# **City of Sierra Madre**

**THE FOLLOWING ARE COMMENTS RECEIVED  
FOR THIS MEETING**

## Comment Letter I95

Re: Draft Environmental Impact Report for The Meadows at Bailey Canyon Specific Plan  
Hickman Comments

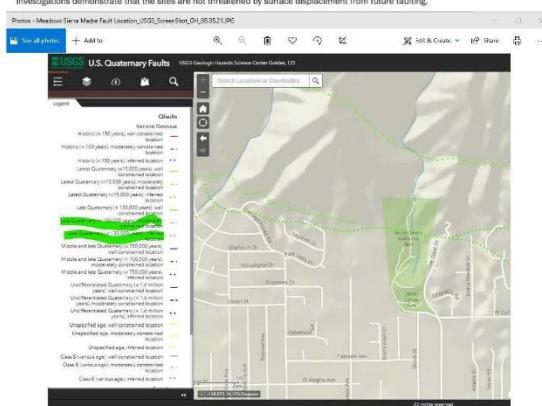
- DEIR Documents: Table ES-1 Summary of Project Impacts: Geology and Soils: & Appendix E, Geologic Section of EIR: “Would the project directly or indirectly cause substantial adverse effects, including the risk of loss, injury, or death involving: a. Rupture of a known earthquake fault.....Geology Special Publication 42? ..... is “Less than Significant.”
  - **Less than Significant is Premature:** The impact statement of “Less than significant” is premature and the corroborating Appendix E (even with the borings taken to suggest a

response to a requirement for “detailed site-specific geologic exploration”) appears to not be in alignment with the depth and breadth of required analysis to negate the severity of the two Late Quaternary Faults. In fact, the report in Appendix E appears to represent a preliminary soils report.

I95-5 The comment expresses concern about the geologic hazards on the project site. The comment states that Appendix E only appears to be a preliminary soils report. It should be noted that Appendix E of the

Draft EIR is a geotechnical report that includes analysis of the geologic conditions and constraints on the site. It should be noted that the excerpt from 4.7.2 that was provided in the comment states the definitions of Late Quaternary and Quaternary faults as defined by the Alquist-Priolo Earthquake Fault Zoning Act, it does not state that there are Late Quaternary faults on the site. Please refer to Response to Comment I36-7.

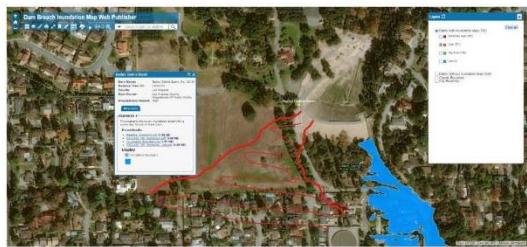
- **Vehicular Access tie-in at Carter and along Carter adjacent to the existing park:** A sound and headlights wall should be constructed along the existing residential. Any street lighting be designed to minimize / mitigate impact to residential property.
- **Provide Vehicular Traffic Flow PTV VISSIM Software Modeling Results:** to demonstrate vehicular impacts to N. Grove Street, FairView Ave, GrandView Ave, West Carter Ave, N. Lima Street, North Sunnyside Ave, etc.

- I95-12 The comment requests traffic flow modeling results that show project impacts on streets such as Grove Street, Fairview Avenue, Grandview Avenue, Carter Avenue, Lima Street, and Sunnyside Avenue. Appendix K, Traffic Conditions Analysis, of this Final EIR has been provided in response to public comments on surrounding street segments. It should be noted that Appendix K has been provided for informational purposes only and does not constitute new information under CEQA, nor does it change

or modify the findings of the Draft EIR. Please refer to Appendix K of this Final EIR for additional information on surrounding roadway segments and intersections analyzed and taken into consideration as part of the proposed project. Please refer to Global Response GR 6.
